**CITY OF LA VISTA  
8116 PARK VIEW BOULEVARD  
LA VISTA, NE 68128  
P: (402) 331-4343**

**PLANNING COMMISSION AGENDA  
AUGUST 17, 2023 – 6:30 P.M.**

**CITY OF LA VISTA  
PLANNING DIVISION  
RECOMMENDATION REPORT**

Re: Val Vista Car Wash; Traffic Impact Study Comment Response Letter

SHEET C2.0

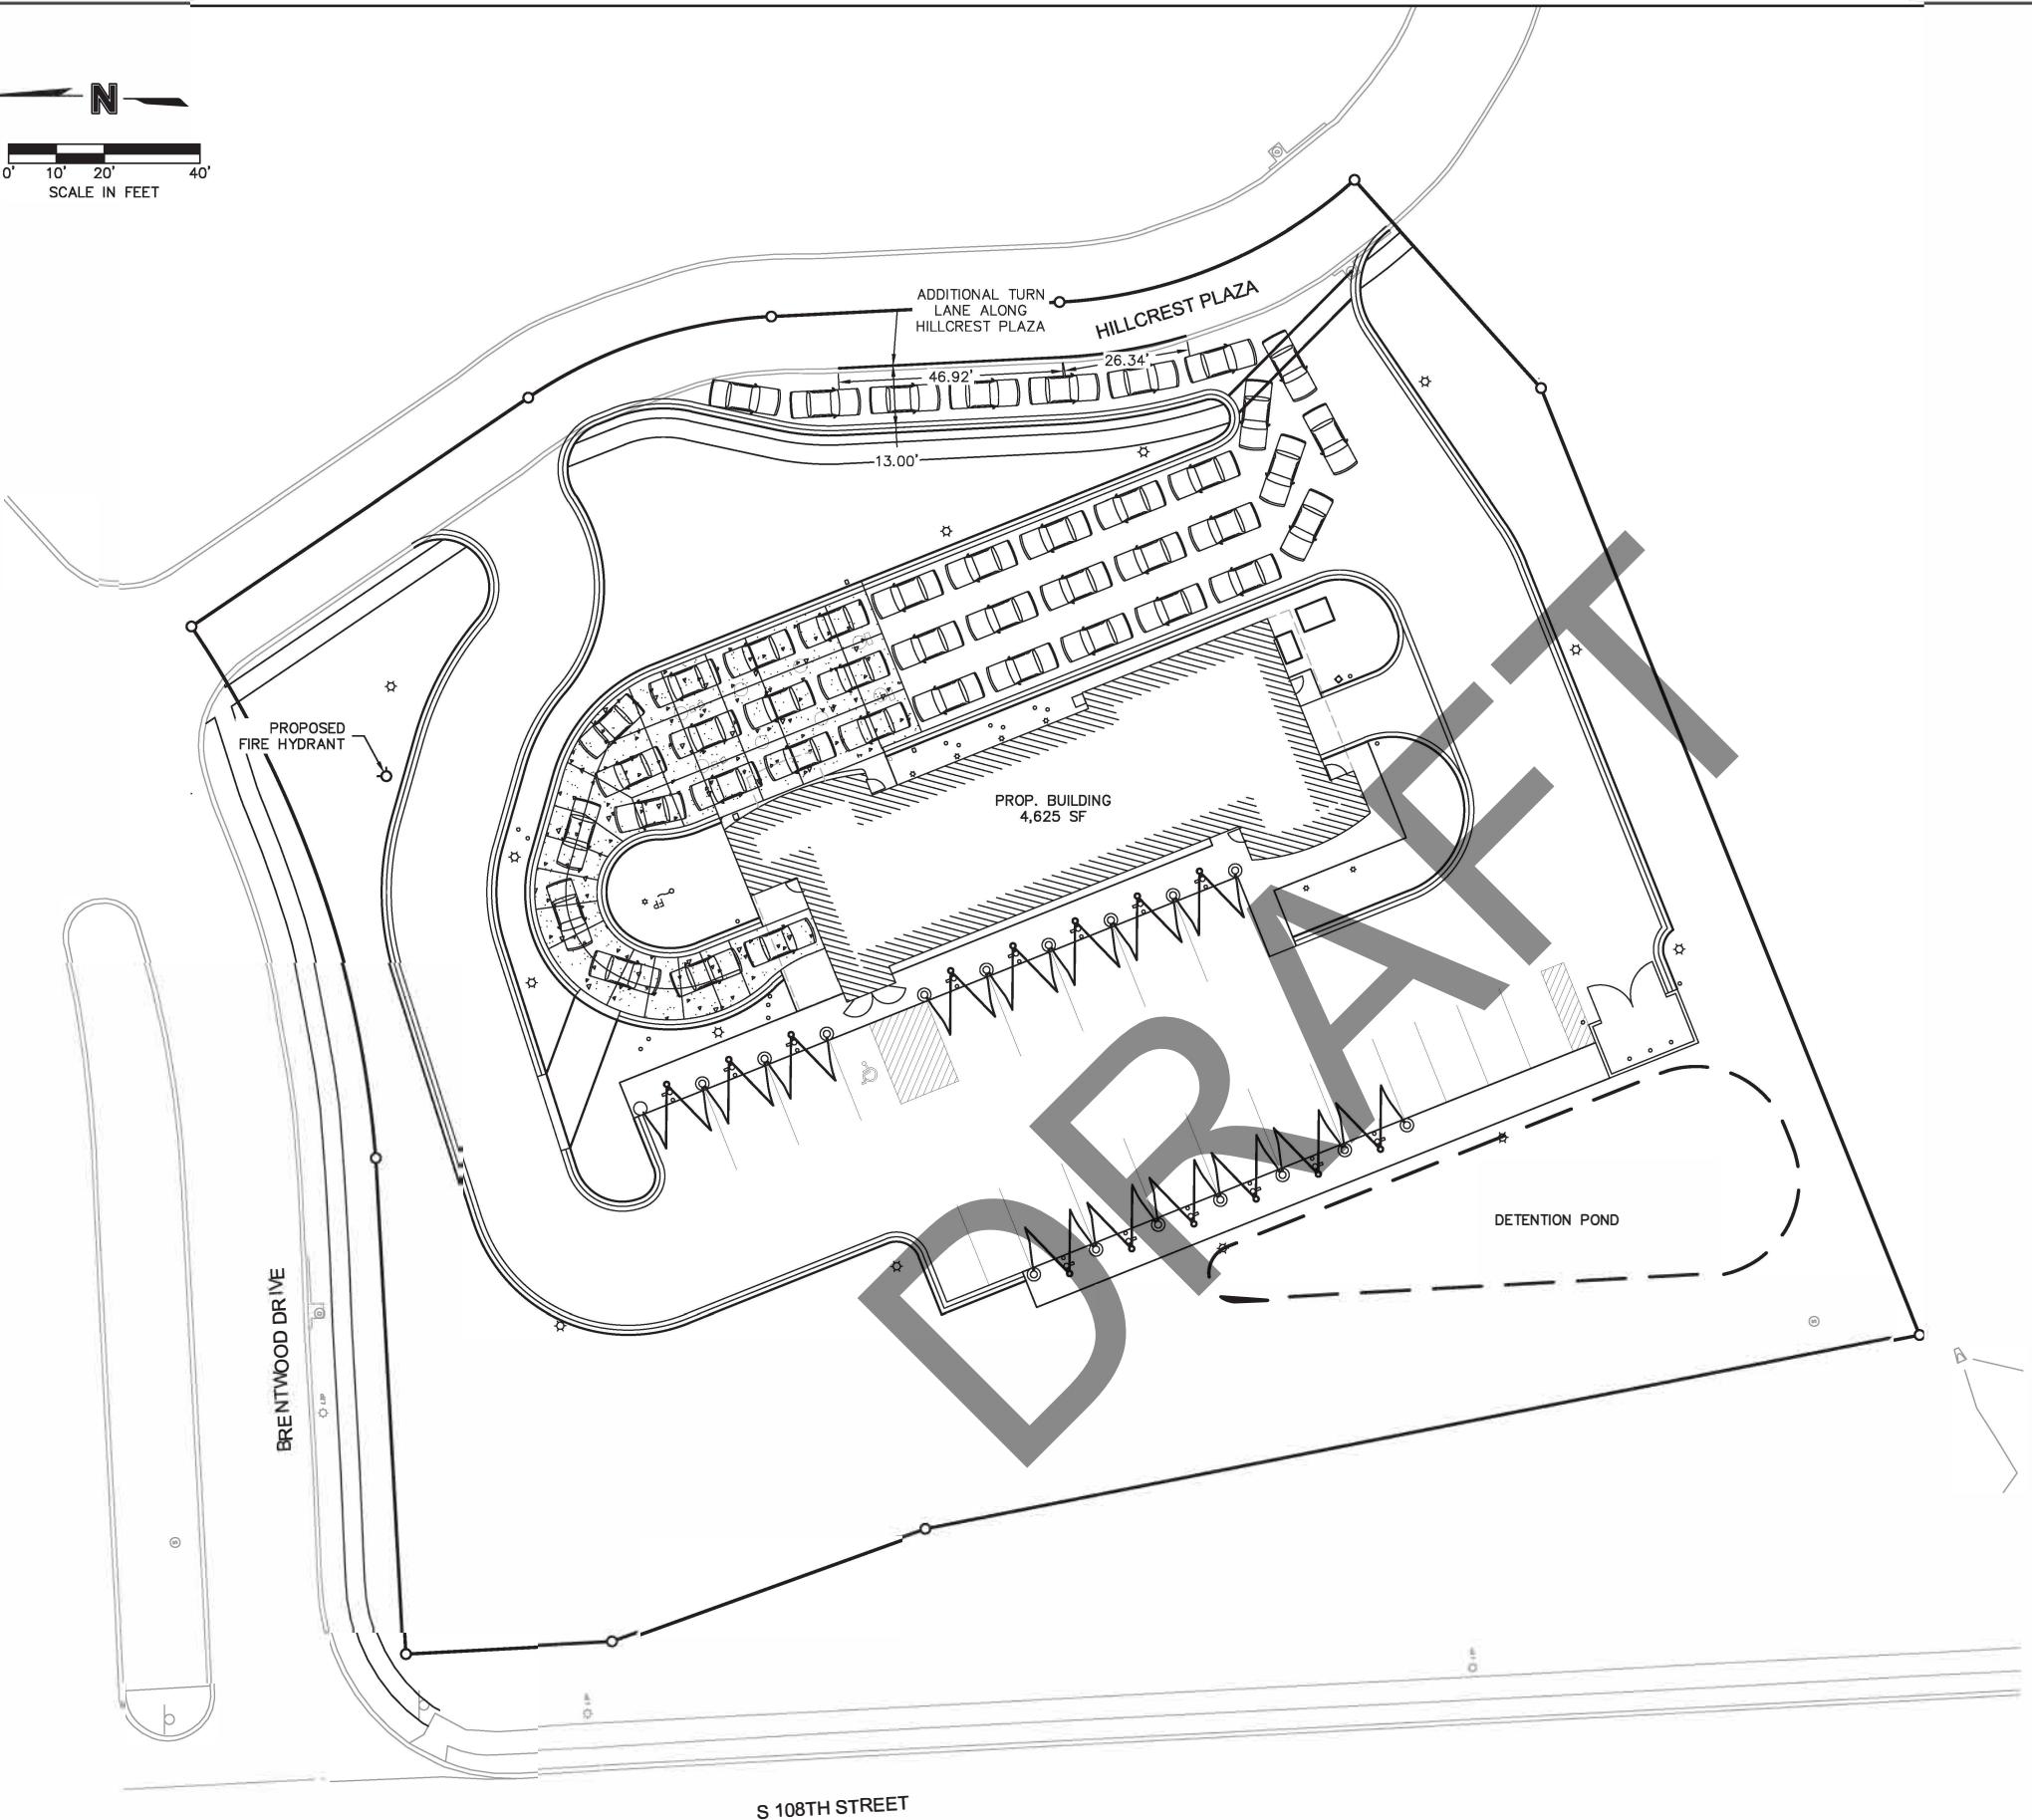
5. There are currently no fire hydrants along Hillcrest Plaza to serve this development. Private fire hydrant(s) will need to be installed. Please include hydrant locations on the site plan or on an additional exhibit.

7. Sidewalks will be required both along Brentwood Drive and Hillcrest Plaza. Please revise the site plan accordingly to represent the required sidewalks.

5. Please see attached updated site plan
6. Please see attached building elevations
7. Please see attached updated site plan
8. Please see attached updated site plan

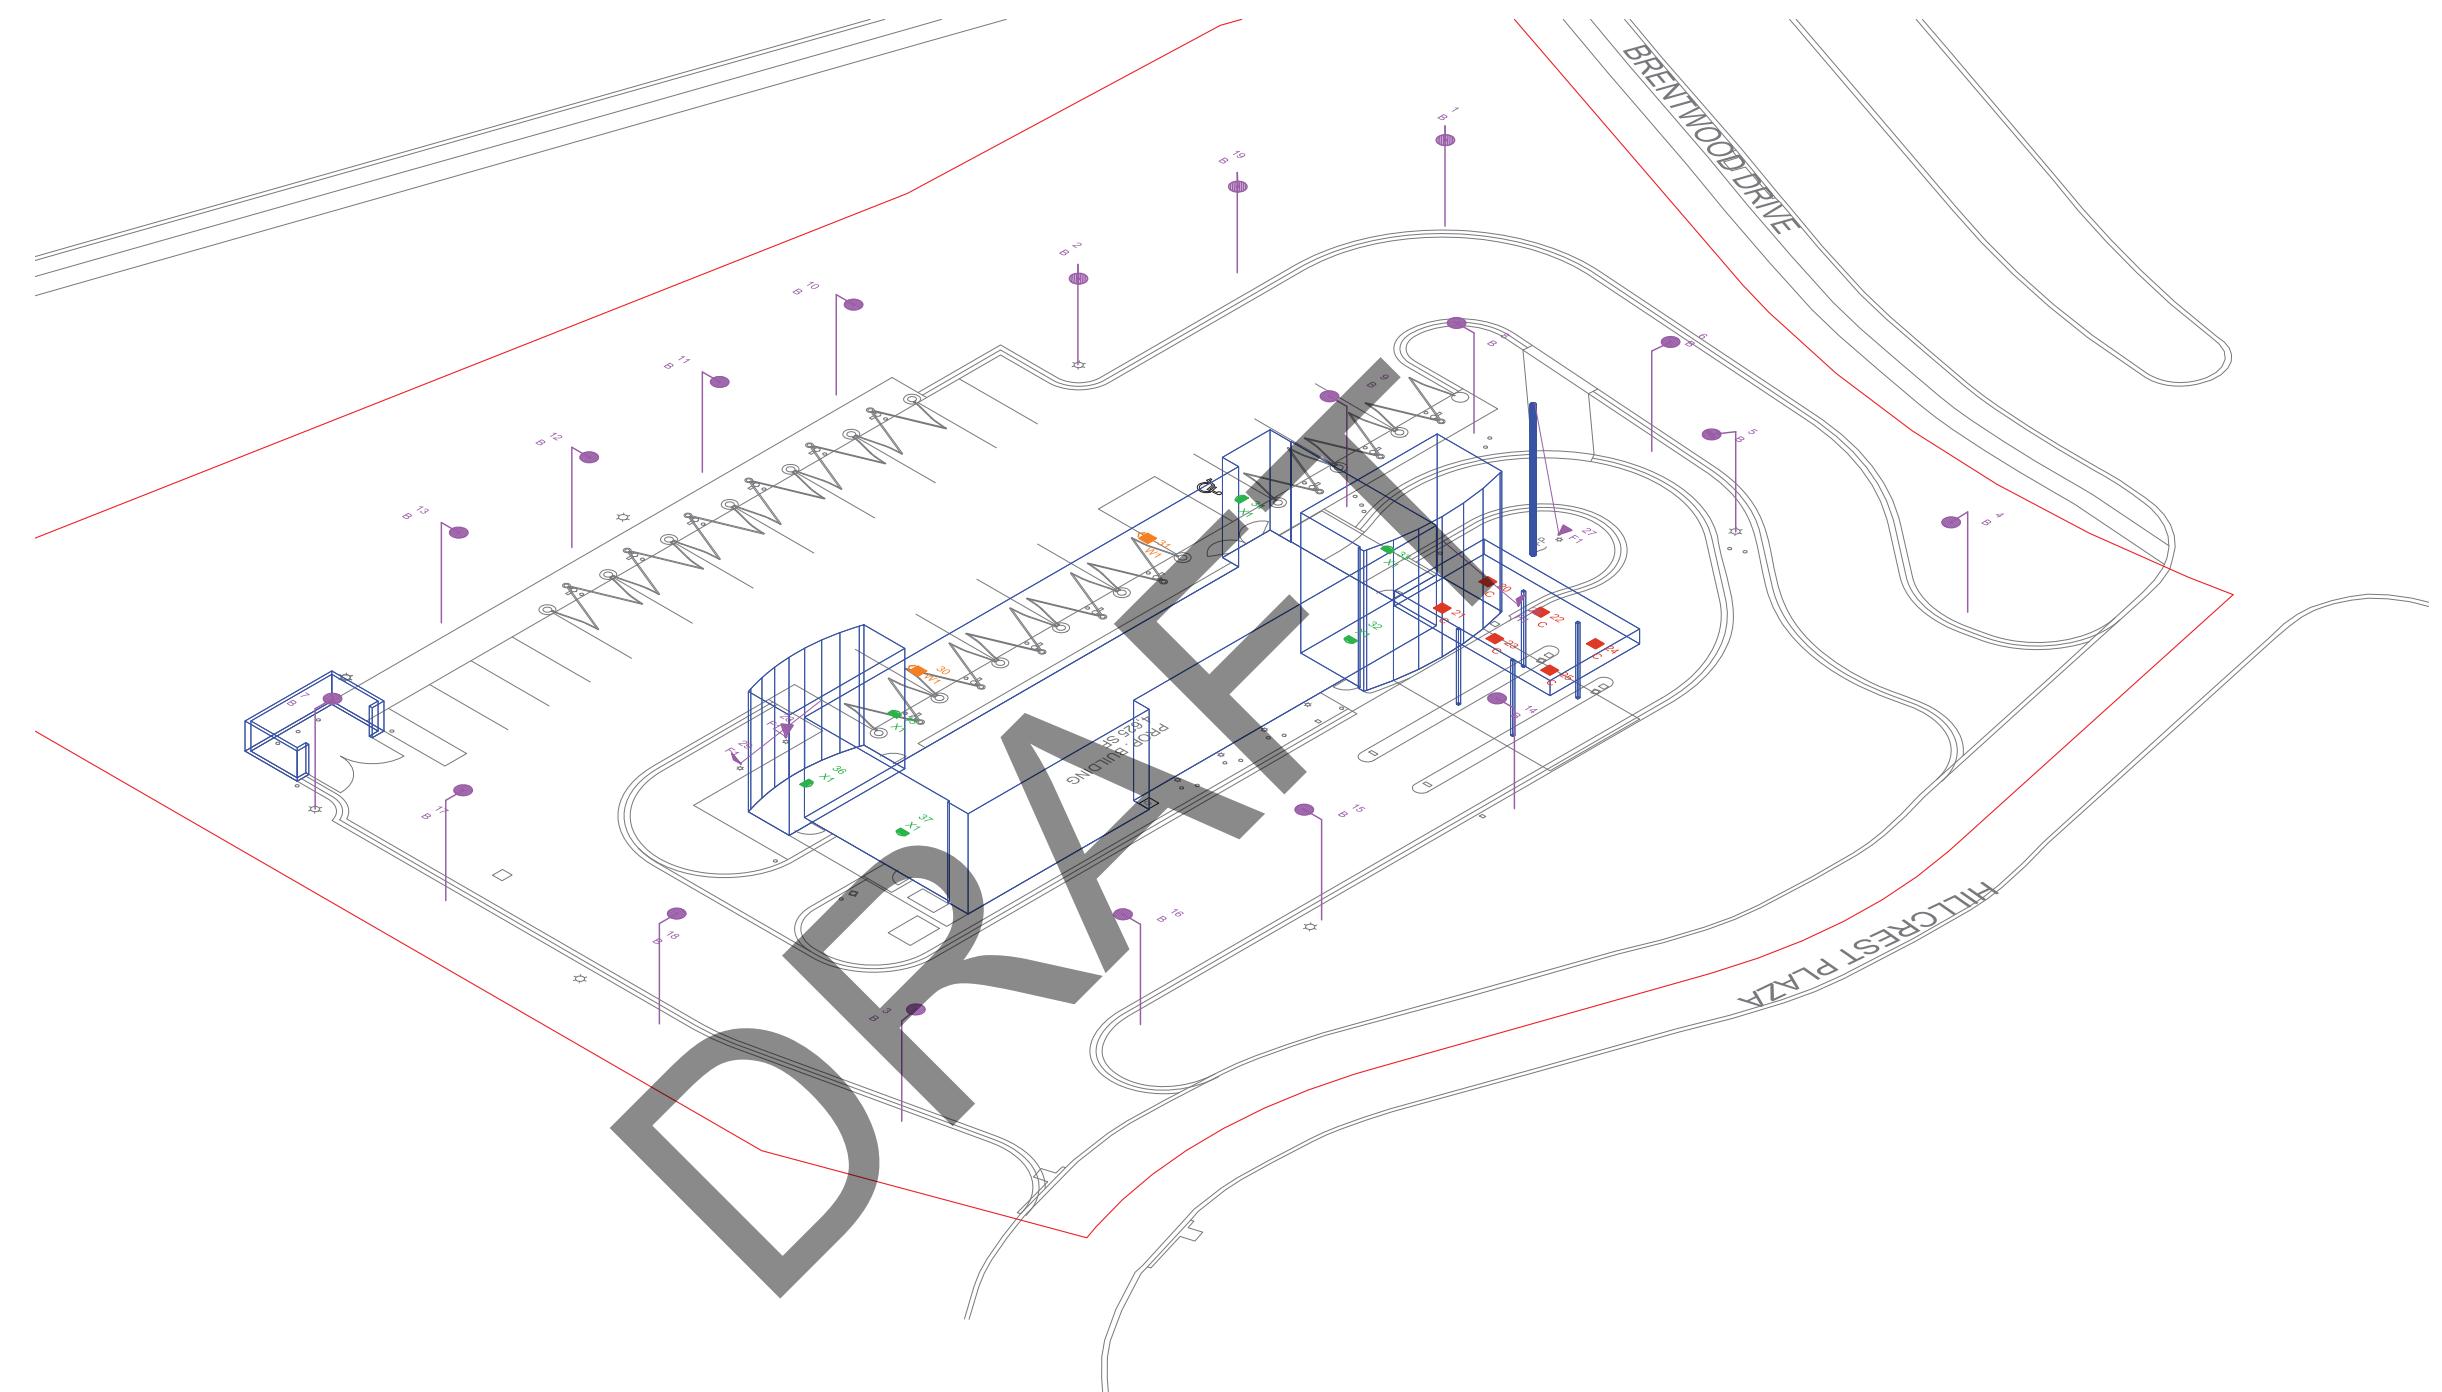
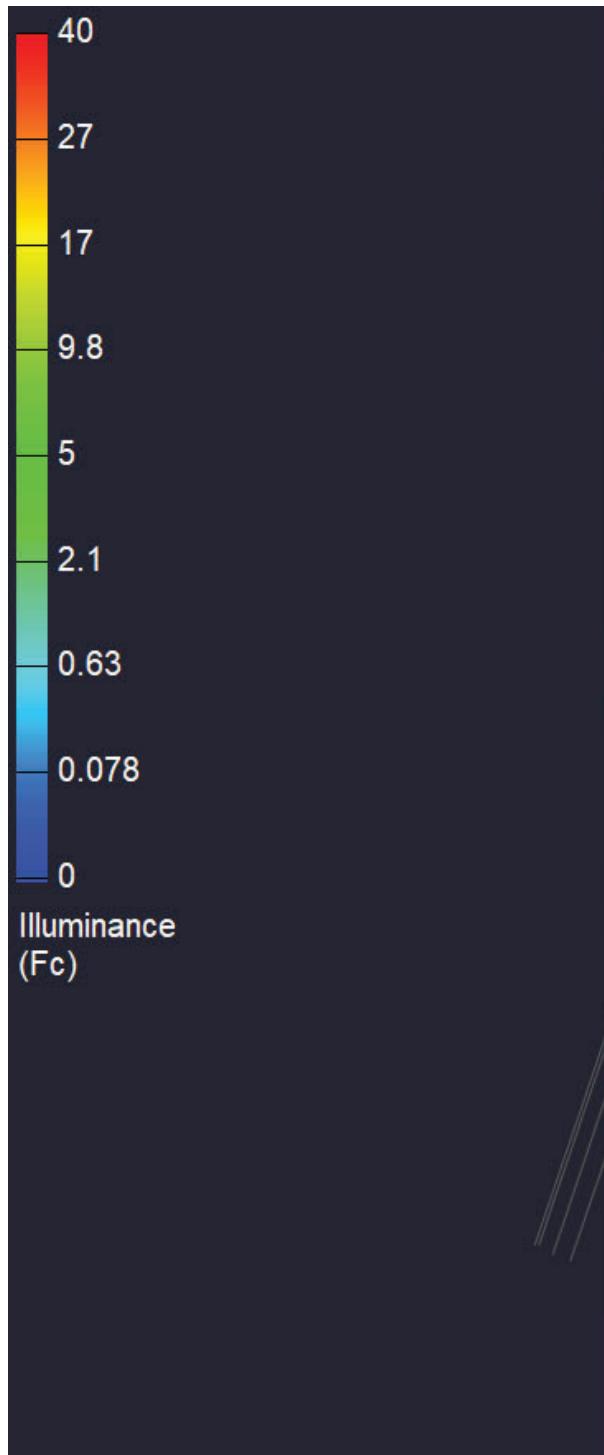
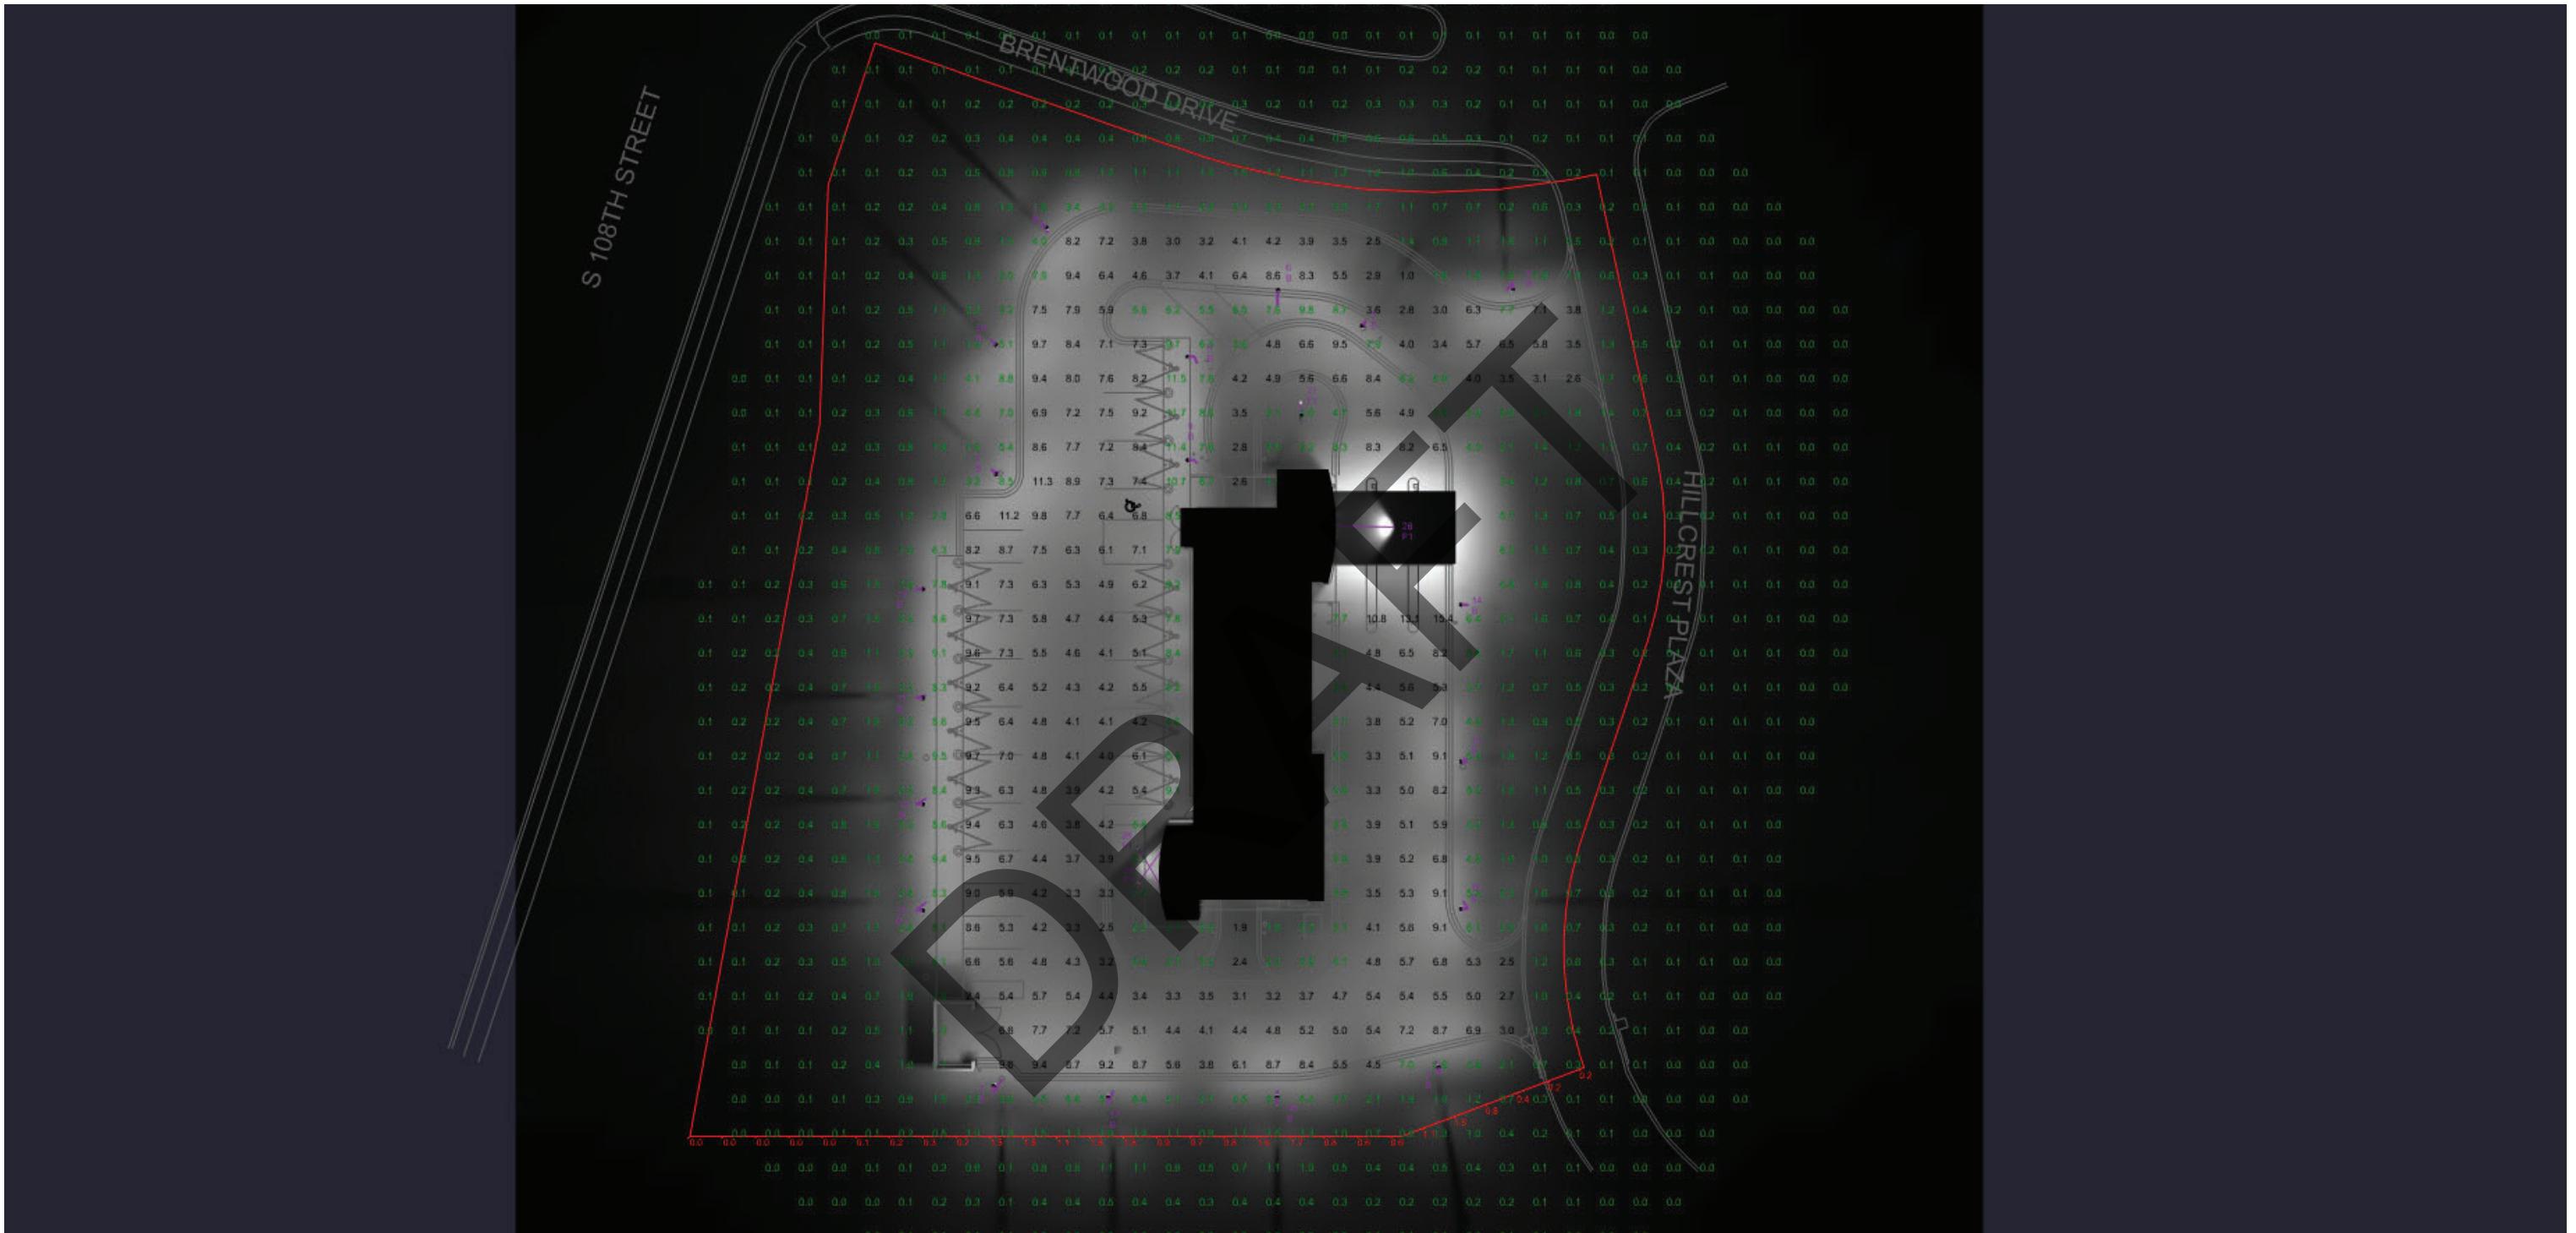
1. Pertaining to Section 6.05.04 of the La Vista Zoning Ordinance, please provide a photometric lighting plan to help us understand the lighting proposed for the site (and/or included in signage) to ensure no light trespass onto adjacent properties. Lot 6 Val Vista Replat One to the east is currently designated for medium-intensity residential development, per the 2022 Future Land Use Plan amendments, and it is imperative that any potential light pollution is avoided.

- f. Site and building lighting, and the impacts of such, shall conform with the photometric plan submitted and attached as Exhibit "E". Any additional site lighting or changes shall be reviewed and approved by the Community Development Department prior to installation to ensure that it does not have a significant negative impact on neighboring properties.
